***Hazardous Waste Ground-Water  
Task Force  
Evaluation of CECOS International, Inc.  
Aber Road Facility  
Williamsburg, Ohio***

***US Environmental Protection Agency  
Ohio Environmental Protection Agency***

UPDATE OF THE HAZARDOUS WASTE GROUND-WATER TASK FORCE  
EVALUATION OF CECOS INTERNATIONAL, INC.

FIGURE 8  
Isopach Map of the 850 Sand  
(taken from S&ME, 1986)

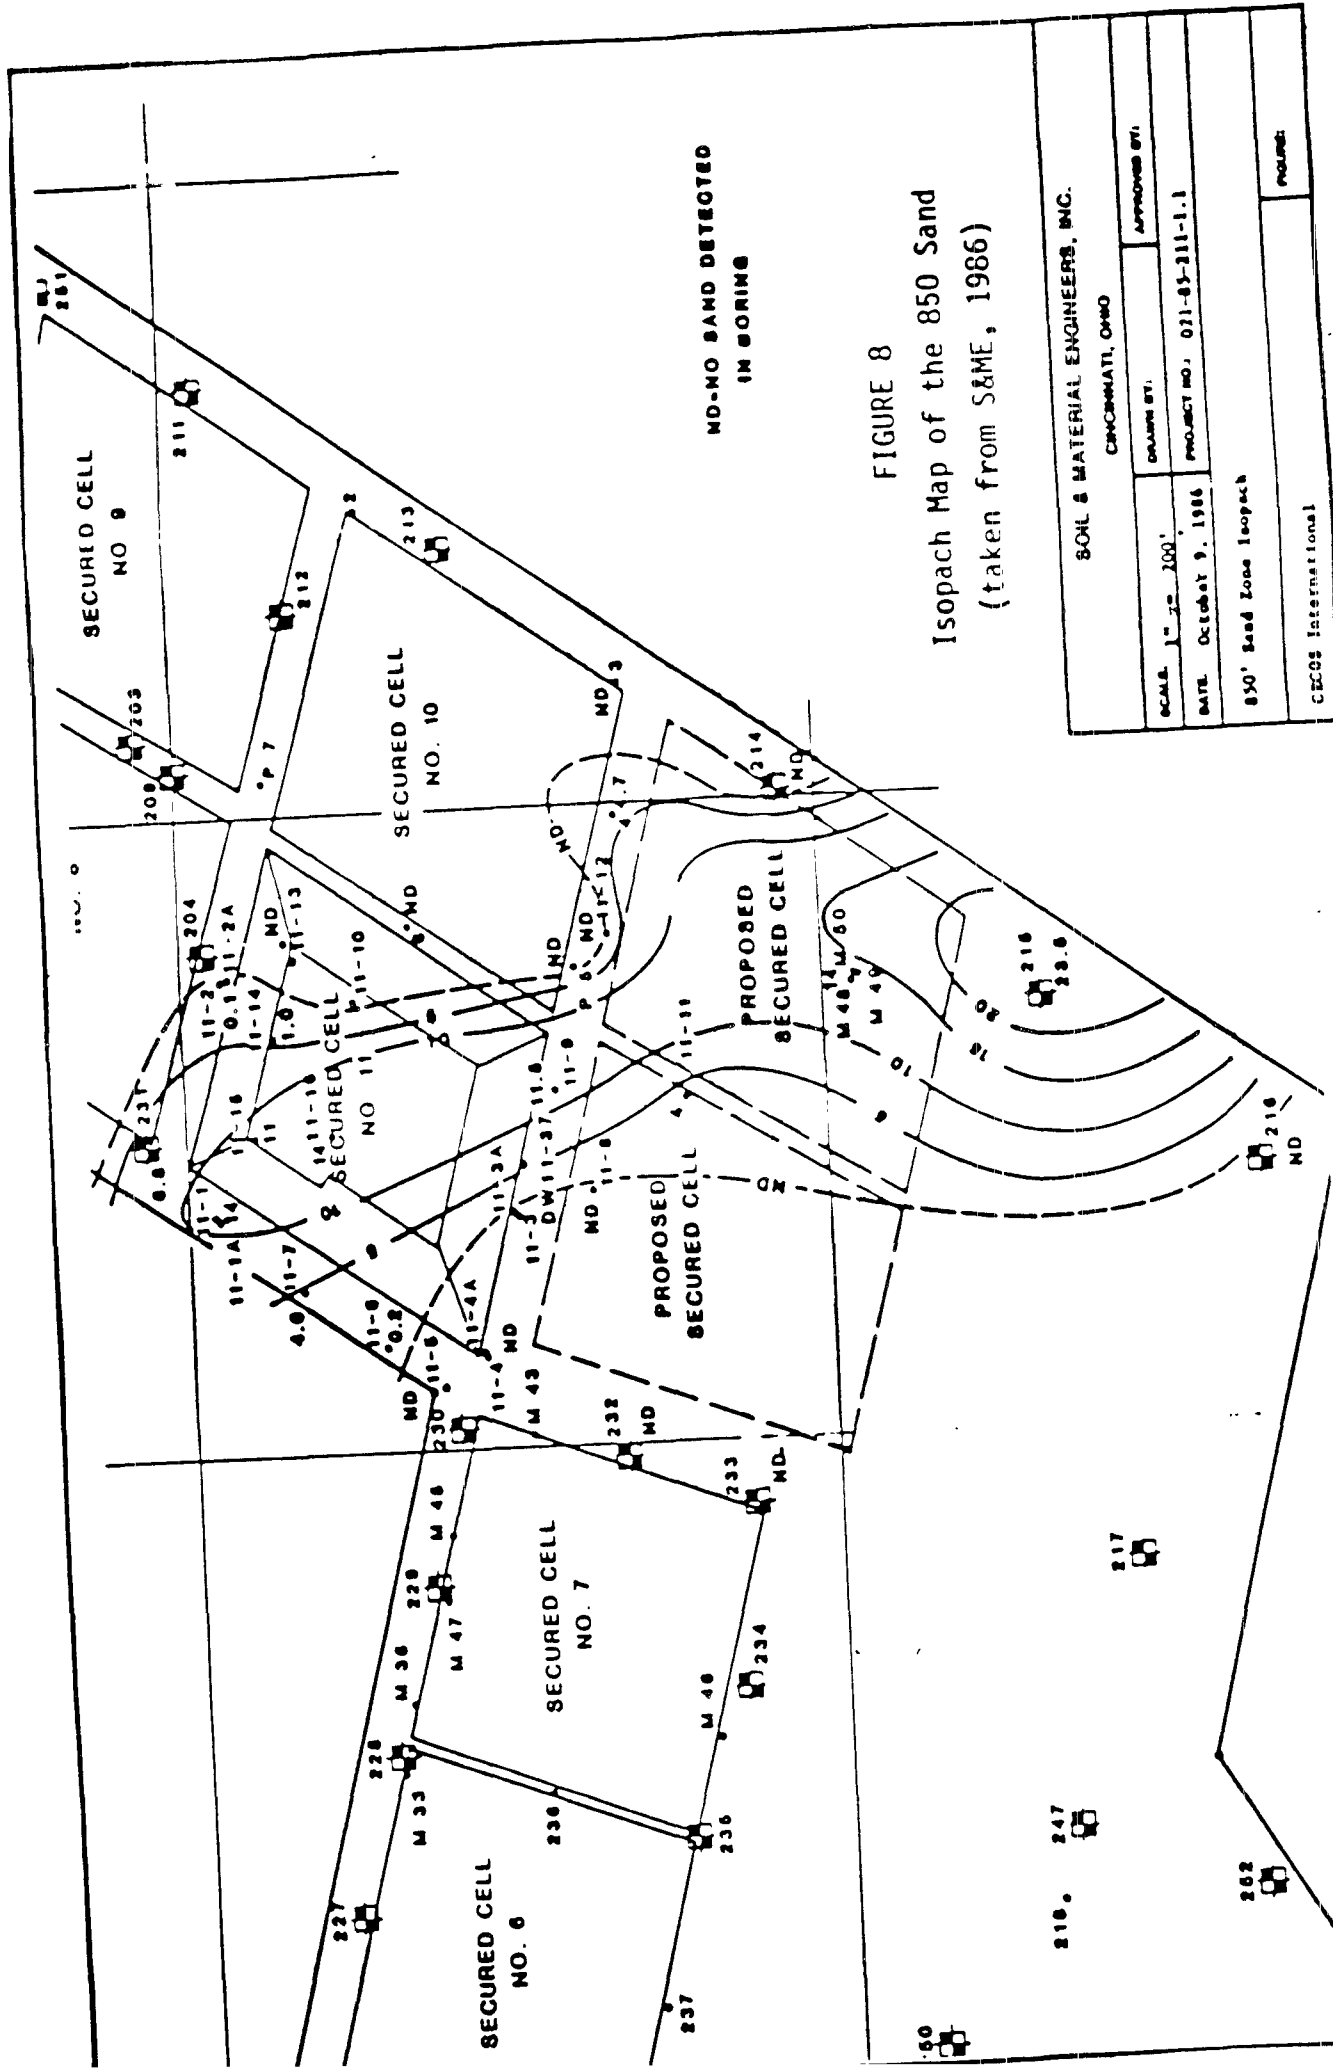
At the time of the evaluation, CECOS was studying the 840 and 850 sands. More information is needed concerning the distribution of these sands and any other lower till sands in the eastern portion of the facility (proximal to Cells 8 through 15 on Figure 2) so that they can be adequately monitored (see discussion below).

After reviewing the available geologic and hydrogeologic information, the Task Force concluded that information is lacking in the eastern portion of the site near Cells 8 through 15, for the interval between 845 feet (msl) and bedrock. Few borings in the eastern portion of the site fully penetrate the glacial tills (see Table 8 and Figure 13). Most of these borings terminate at or above 846 feet (msl). The lack of information below this elevation in the eastern area precludes evaluation of whether the lower till sands are adequately mapped and therefore if the monitoring system is adequate in these areas. Further geologic investigation is required (e.g., continuous cores and the determination of ground water flow directions) to determine the

Figure 15 - Proposed RCRA Ground Water Monitoring System (taken from CECOS, 1986 - Proposed Ground Water Monitoring Program).

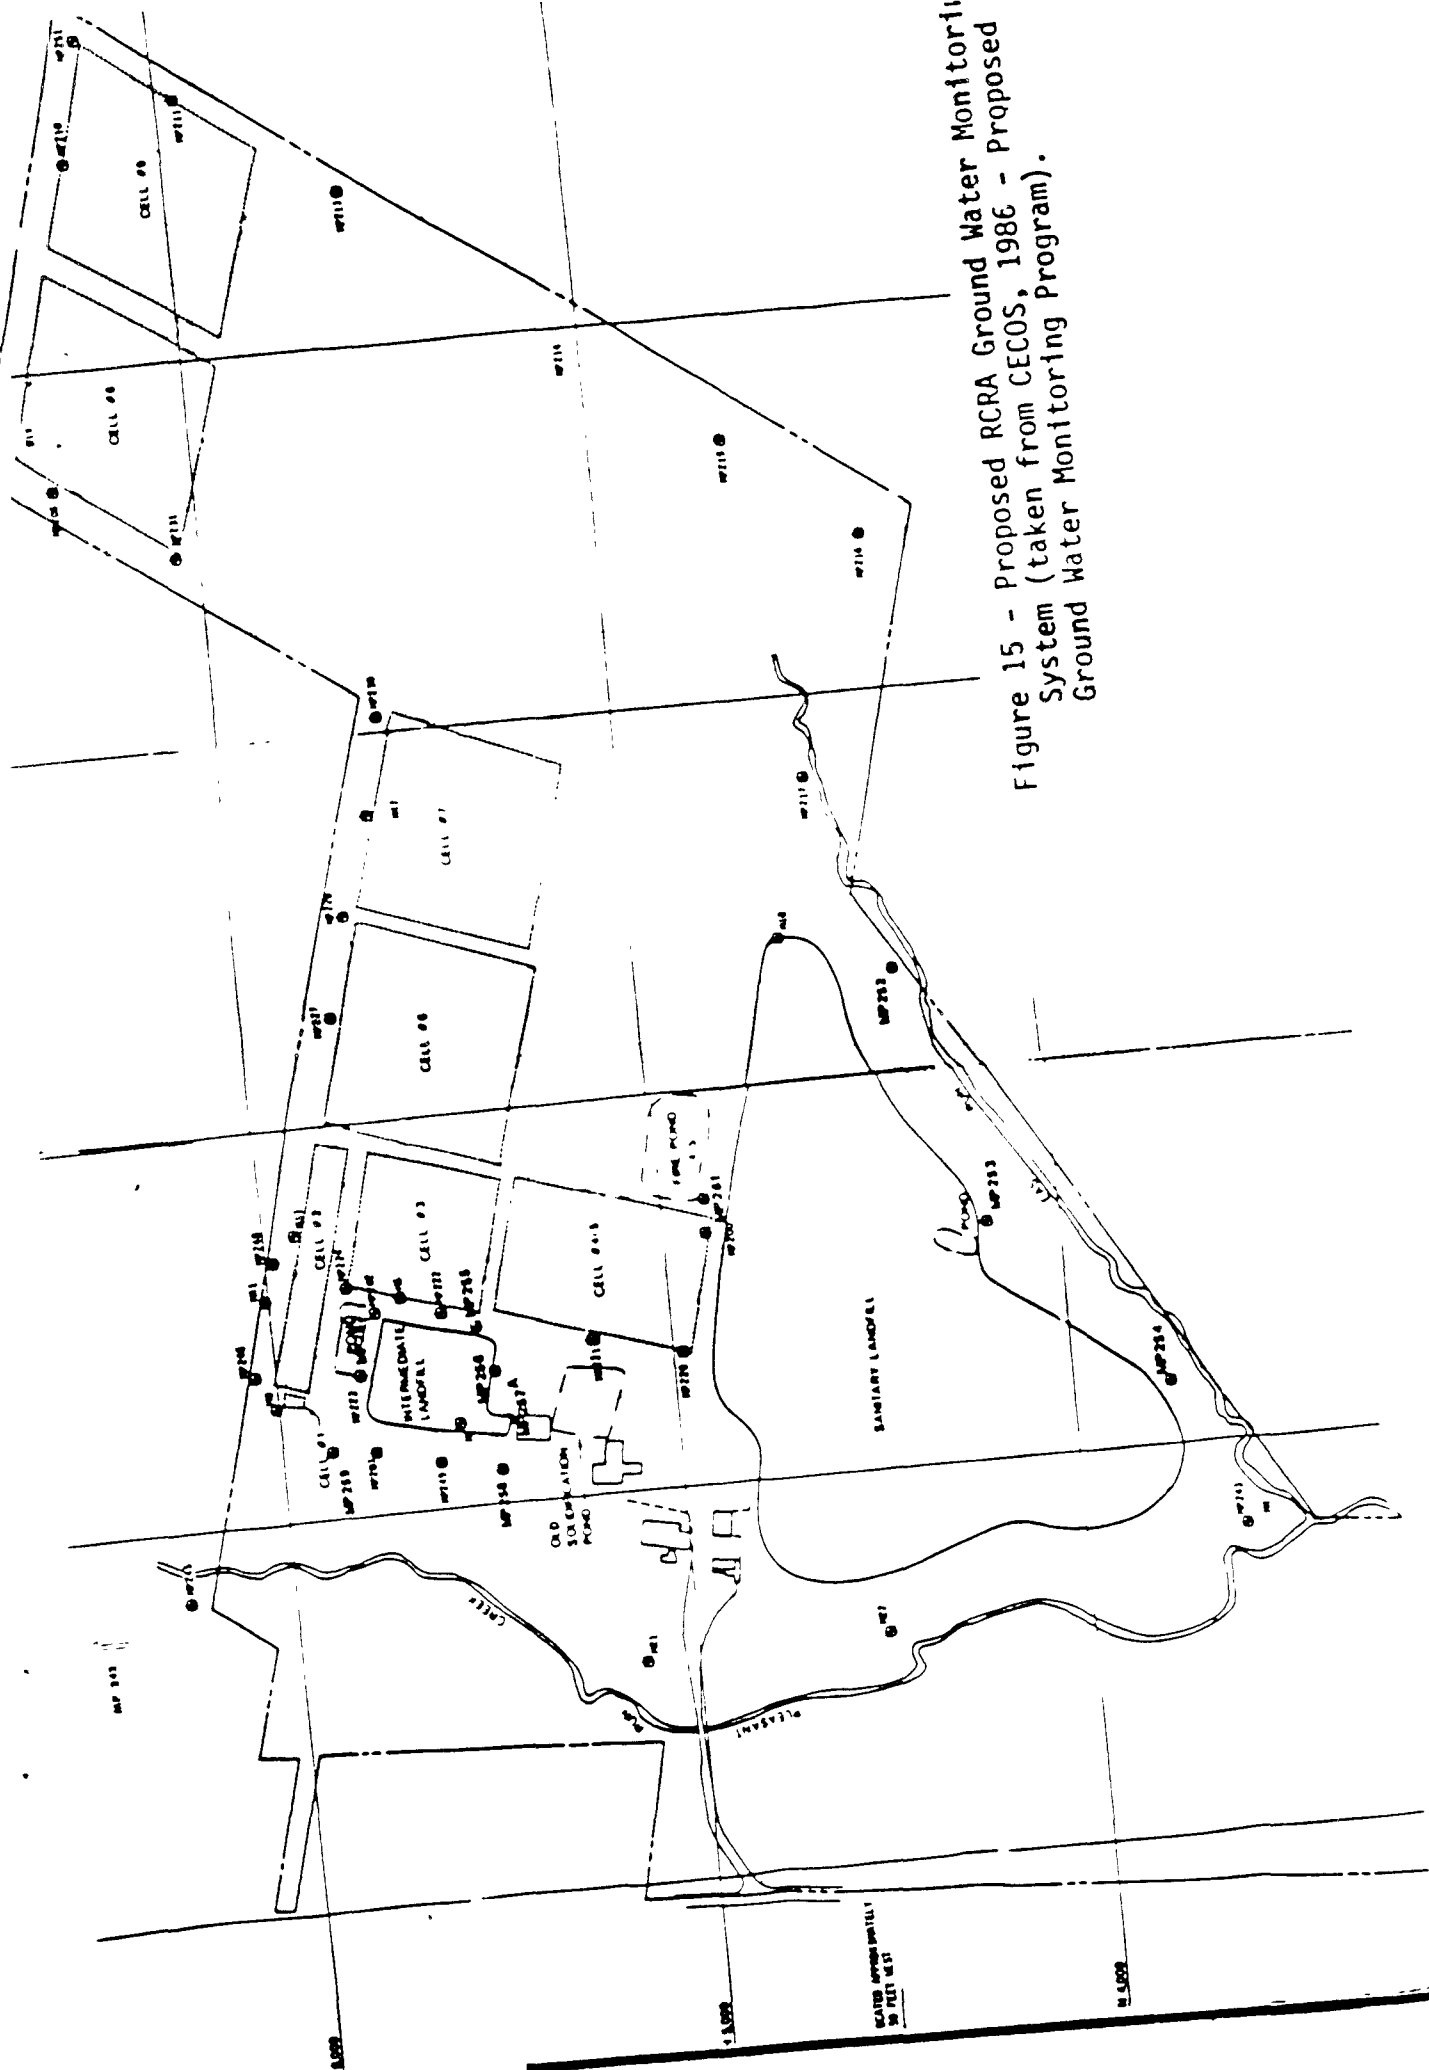
In response to a request by the U.S. EPA and Ohio EPA at a meeting held in Columbus, Ohio, in August 1986, and as recommended by Warzyn (1986), CECOS prepared a report describing a Proposed Ground Water Monitoring Program (CECOS, 1986) that was intended to satisfy all of the monitoring requirements of RCRA, TSCA, and the Ohio PTI. This program was evaluated by the Task Force and found to be inadequate. The proposed system is shown on Figure 15 and is listed in Tables 4 through 7. The inadequacies under RCRA noted by the Task Force in the Proposed

c. Downgradient Wells. The number of downgradient wells in the existing system (See Table 4 through 7) is sufficient. In response to a meeting with the U.S. EPA and Ohio EPA in Columbus on August 13, 1986 and recommendations by Warzyn (1986), CECOS has proposed a single Comprehensive Ground Water Monitoring Program (CECOS, 1986) that includes downgradient wells in many of the sand units (see Tables 4 through 7). Although this program would be a significant improvement over the current system, the Task Force determined the proposed system does not have sufficient wells to immediately detect or assess contamination from the existing cells into all of the sand deposits in contact with the cells. Further, some of the existing wells in the proposed system are inadequately constructed. The Task Force recommends that the downgradient wells in the proposed system with inadequate construction (see below) be replaced if CECOS intends to use them.

Figure 16 - RCRA Ground Water Monitoring System Recommended by the Task Force.

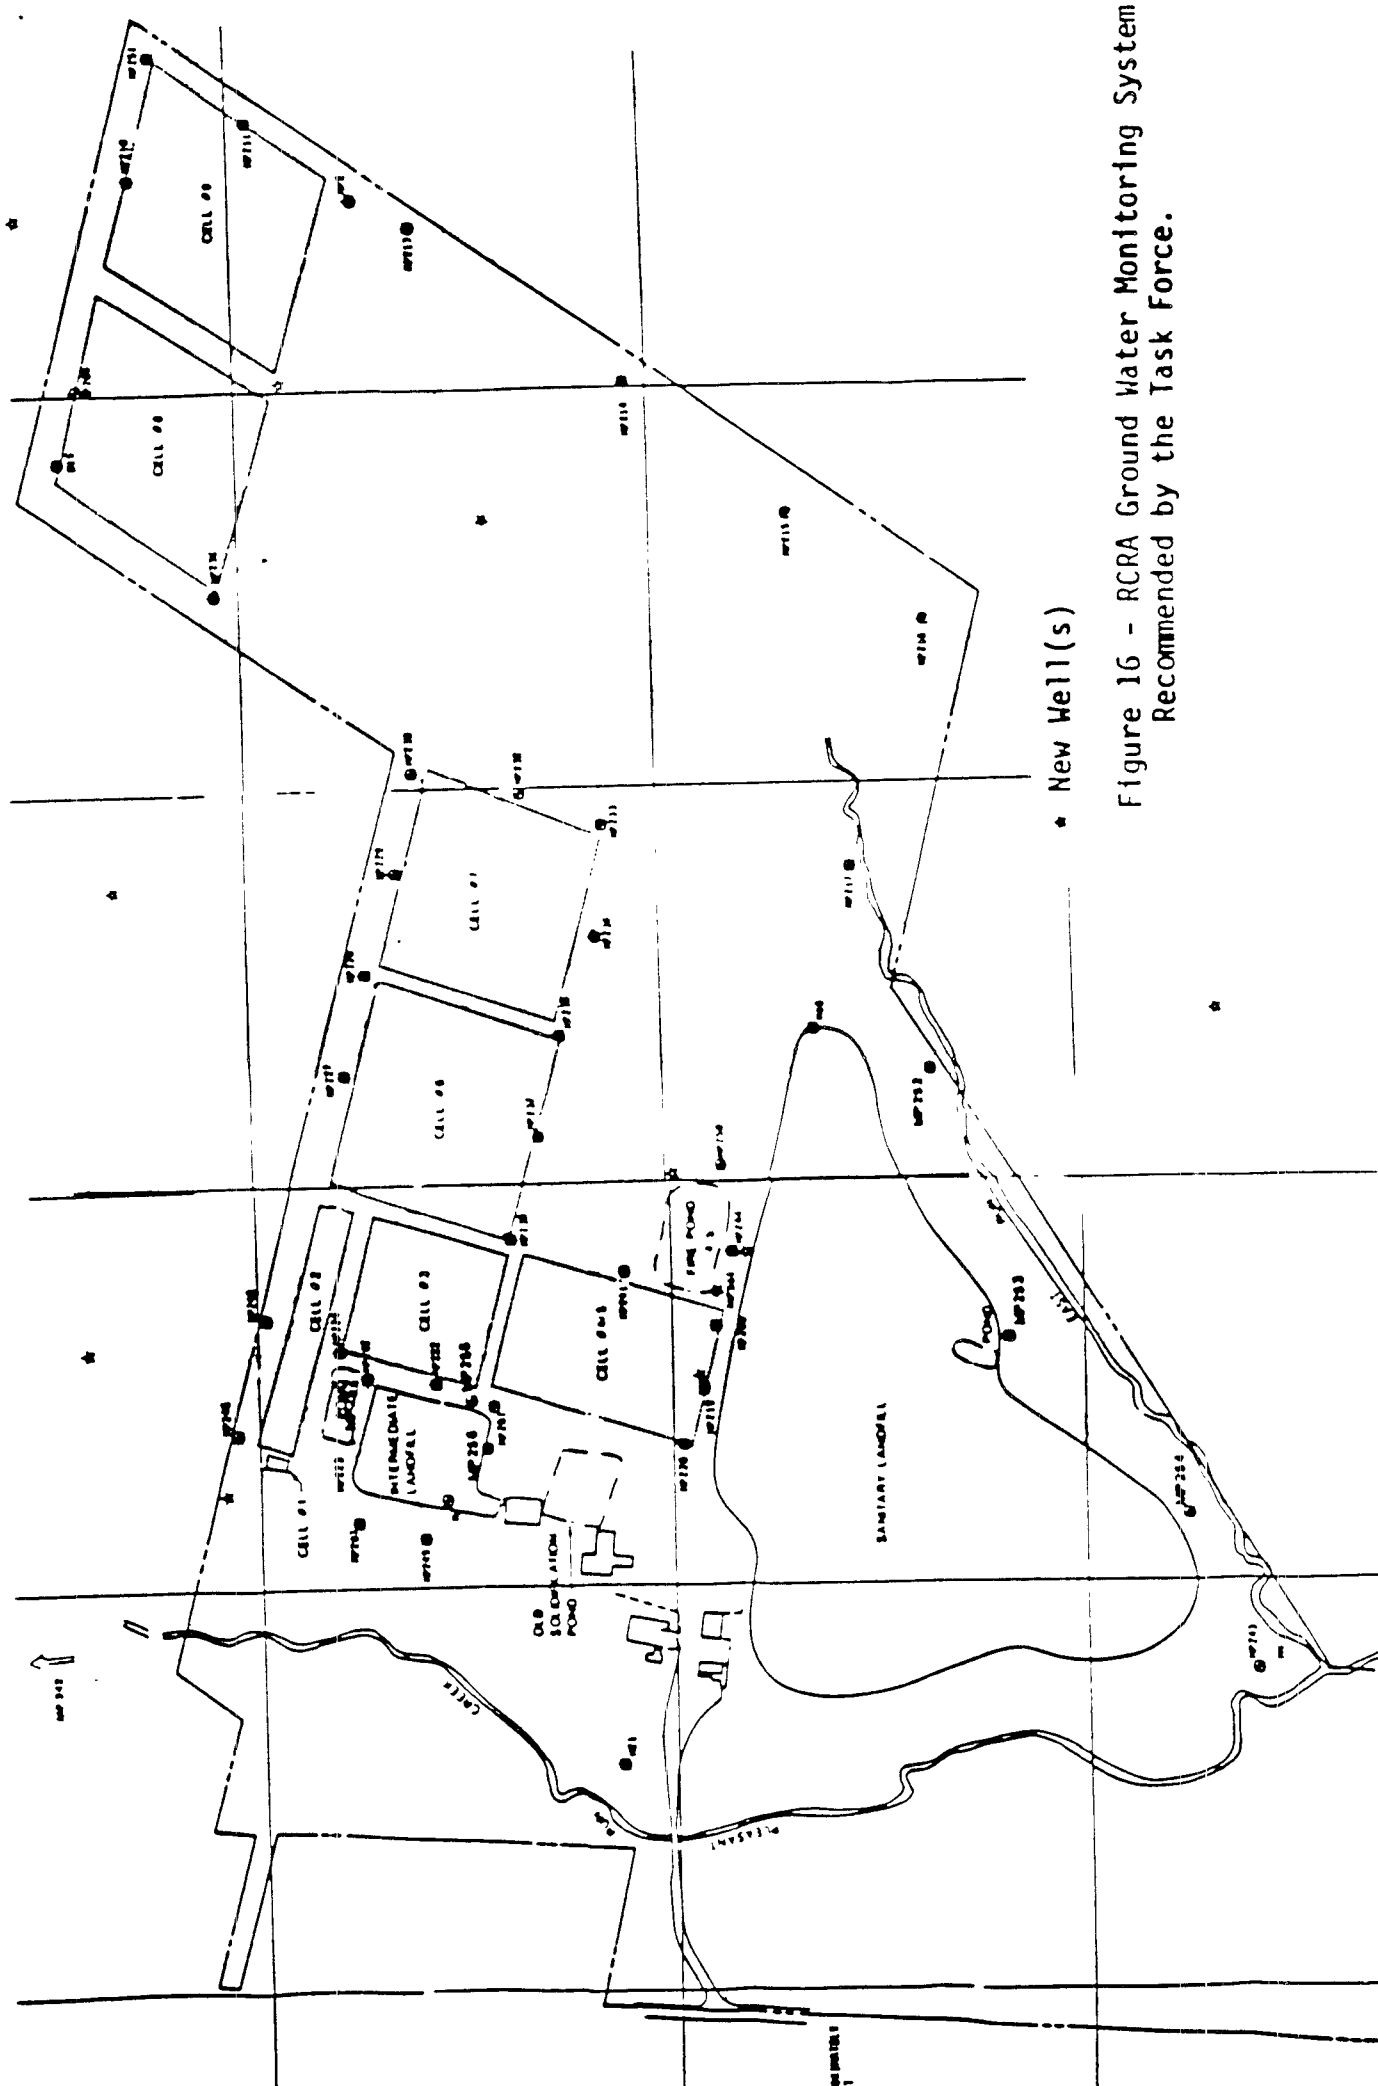
Future monitoring wells used for collection of samples should be constructed with inert casing materials. Because of the nature of the wastes landfilled at the CECOS Aber Road facility stainless steel (304, 316, or 2205) or polytetrafluoroethylene (PTFE) are the best-suited materials. The Task Force has determined that it is not necessary to replace properly designed and built existing wells solely because they are constructed with PVC casing.
